Dear Professor Zehe, dear reviewers,

Matthias Zink, Rohini Kumar, Matthias Cuntz, and Luis Samaniego

# 1 Anonymous Referee #1

Figure 3: Relation of model performance and catchment area for the 222 basins.

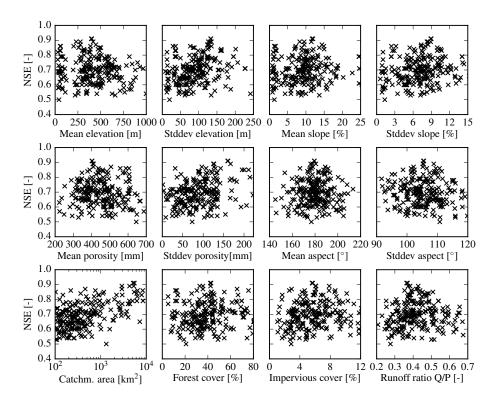
The validation watersheds range in size by nearly two orders of magnitude. If the model spatial resolution is the same for all, the authors should comment and hypothesize whether they see higher model performance in larger basins. Does performance increase monotonically with basin size?

We comment on this issue in the manuscript as "However, a tendency to perform better in large catchments basins is observed." We also note that there is no clear (monotonic) relationship between basin area and NSE as can be observed from the Figure 3 below.

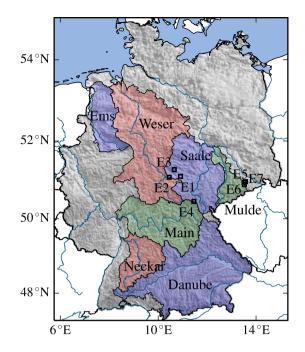
Figure 1: What do colors represent? Please describe in figure caption.

The colors are only to better distinguish the different catchments. We added an explanation to the caption.

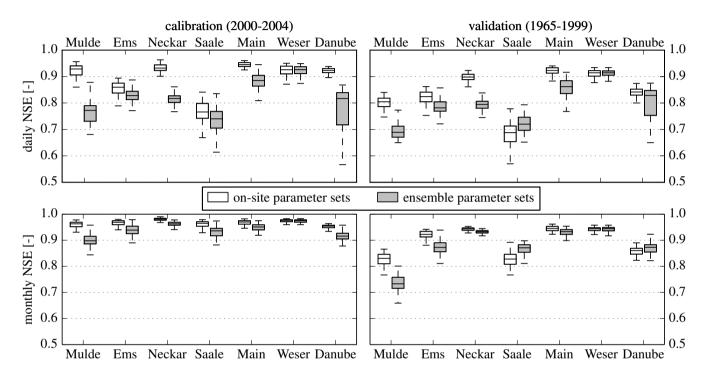
Figure 2: Shouldn't this be filled white?

The parameter selection procedure is applied to model performances on daily basis in the validation period (see section 3.2). Thus, the grey boxes in the upper right panel of Figure 2 show the resulting performances after parameter selection. All of the whiskers are exceeding an NSE of 0.65.

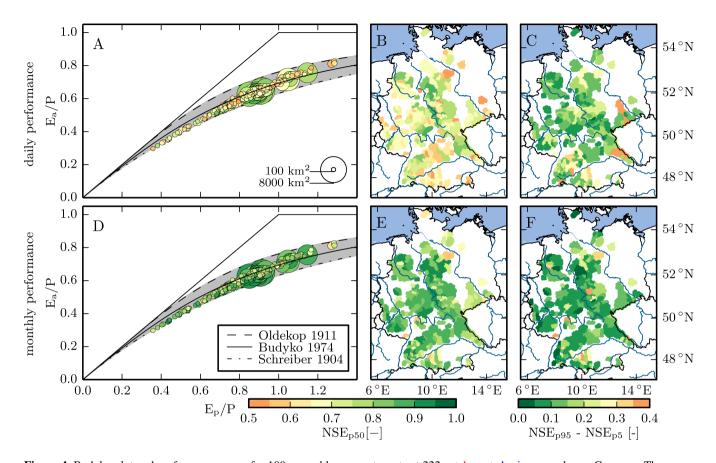
Page 10, lines 16-24: You discuss the energy- and water-limited conditions, which could also be added to the figure. It also appears that at this point the data switch from under representation to over representation (within the uncertainty bounds). Please discuss this.

Figure 4: Using the same color scale is a little misleading. Include the locations of the eddy covariance stations on the map.

In Figure 4, climatic regime does not appear to be a good predictor of model performance, with some of the highest NSE scores distributed throughout the range of conditions. The authors should comment on what, if anything, will best predict model performance, to guide a potential user of the dataset.

Since Figure 4 has already a high information content, we dare to add further information as, e.g., the separation to energy and water limited areas, by introducing another line or coloring. Nevertheless, we elaborated the caption of the figure to address this point. We discuss the issue of under- and overrepresentation in the text now. Thank you for pointing this out.

The location of the eddy covariance stations are depicted in Figure 1. We have chosen the same colors for the Budyko plot and the map plot to give the reader the opportunity to see wether model performances are clustering for a particular climatic regime and/or geographical location. For the maps on the right side, we are using the inverse color bar. We intend to ease up the comparison of catchments showing a relatively good performance (green) with relative low NSE ranges (green) and vice versa.

Fortunately, we did not find any meteorological or morphological characteristics which explained why model performance is different for different catchments. This makes us confident that the retrieved parameter sets are representative for various climatic and physiographic conditions. We performed an analysis for identifying relations between land surface and hydro-climatic characteristics and model performance. Figure 4 was added in the revised manuscript and the findings are shortly discussed in section 4.2 of the revised manuscript.

Figure 5. Observed  $(E_{a,obs})$  versus ensemble median modeled evapotranspiration  $(E_{a,mod})$  on daily basis at the seven eddy covariance stations (Figure 1, Table 2).

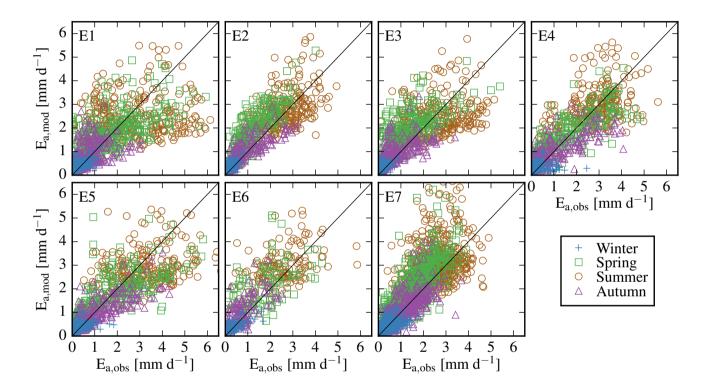
Page 11, line 5: Your data groupings get confusing here. In the figure daily and monthly (I think?) data are grouped by color in seasons. In the table you report monthly and daily values. Be explicitly clear about what is being reported here. Maybe have a different symbol for monthly and daily data to differentiate (if they are both in the scatterplots. . . still not clear.).

Figure 5: Consider changing symbols so that this figure is readable in black and white.

The scatterplot only shows daily data. We adopted the figure caption accordingly.

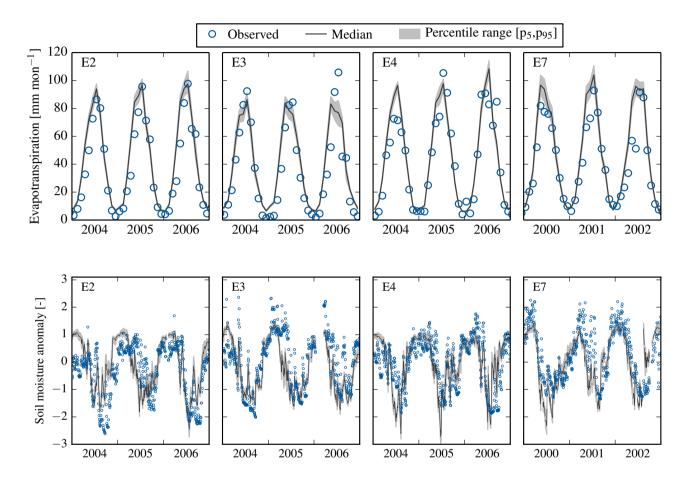
Figure 6: Why are these four stations selected?

Figure 6: observations hardly visible - please improve

First, of all to represent the major mHM land cover classes (forest and mixed) are represented. And second, because they have at least continuous 3 year long time series without big data gaps. Further the four station are spread over the three regions where eddy covariance observations are available. We added this reasoning to the figure caption.

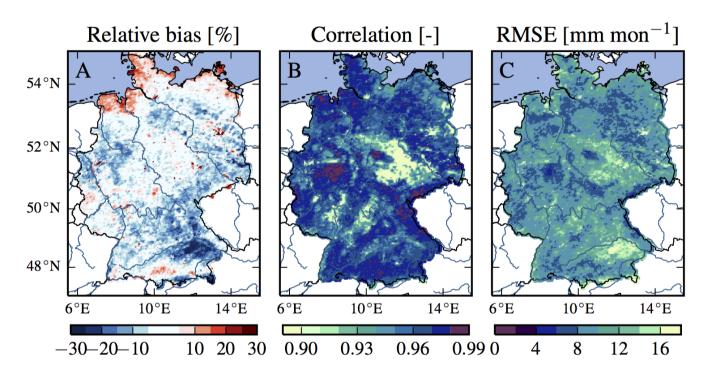
Further, the authors should comment more directly on why they did not evaluate the spatial patterns of their model against remotely-sensed ET and consider doing this evaluation. Thank you for mentioning this point. We added a comparison of the ensemble mean of modeled evapotranspiration with MODIS evapotranspiration. We elaborated the results of this comparison in the revised manuscript and added Figure 2 to the manuscript).

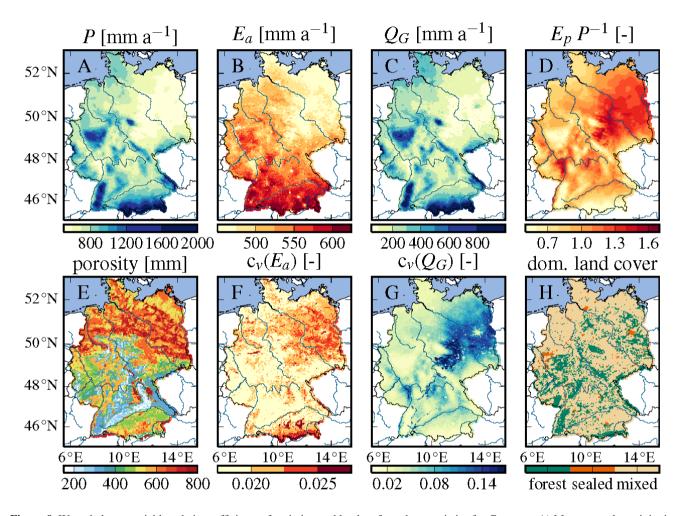
Page 12, line 11: These features (Central Uplands, Alps) are not on the map.

Figure 7: The Central Uplands and Alps (referenced on page 12, line 11) are not explicitly shown on this map.

We changed the text in way that the location can be identified on the map in Figure 9.

We changed the text such that the location can be identified on the map in Figure 9.

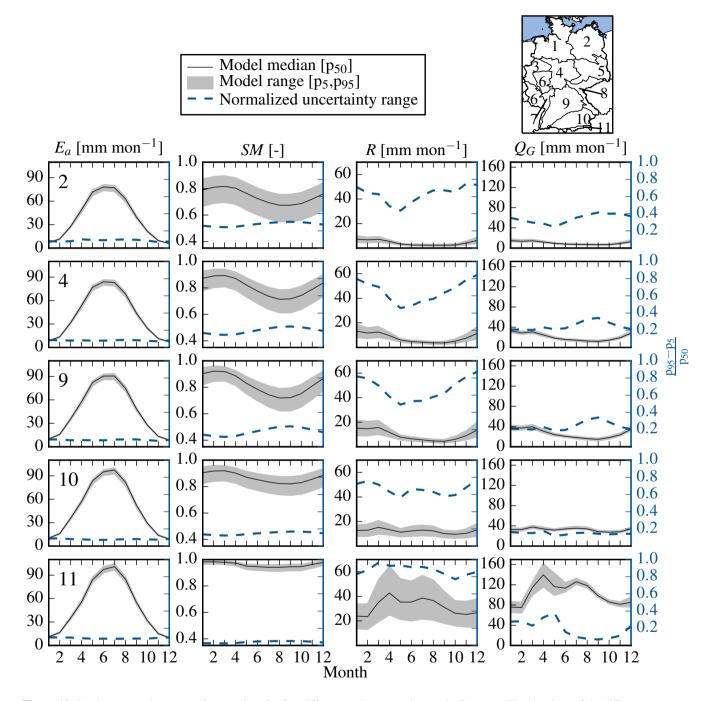
Figure 9: The information on the range of uncertainties is provided by the grey area enveloping the median. I don't think the normalized range adds significantly more information to that - delete?

We argue that the normalization of the ranges is needed for the comparison of uncertainties among the hydrologic variables. Also interpreting the uncertainty behavior through the course of a year is more difficult without proper normalization. The uncertainty in evapotranspiration, for example, does not significantly change over the course of a year. Such a behavior would be difficult to observe without the normalized ranges. For that reason we prefer to stay with the figure as it is. 4 The marked-up manuscript version
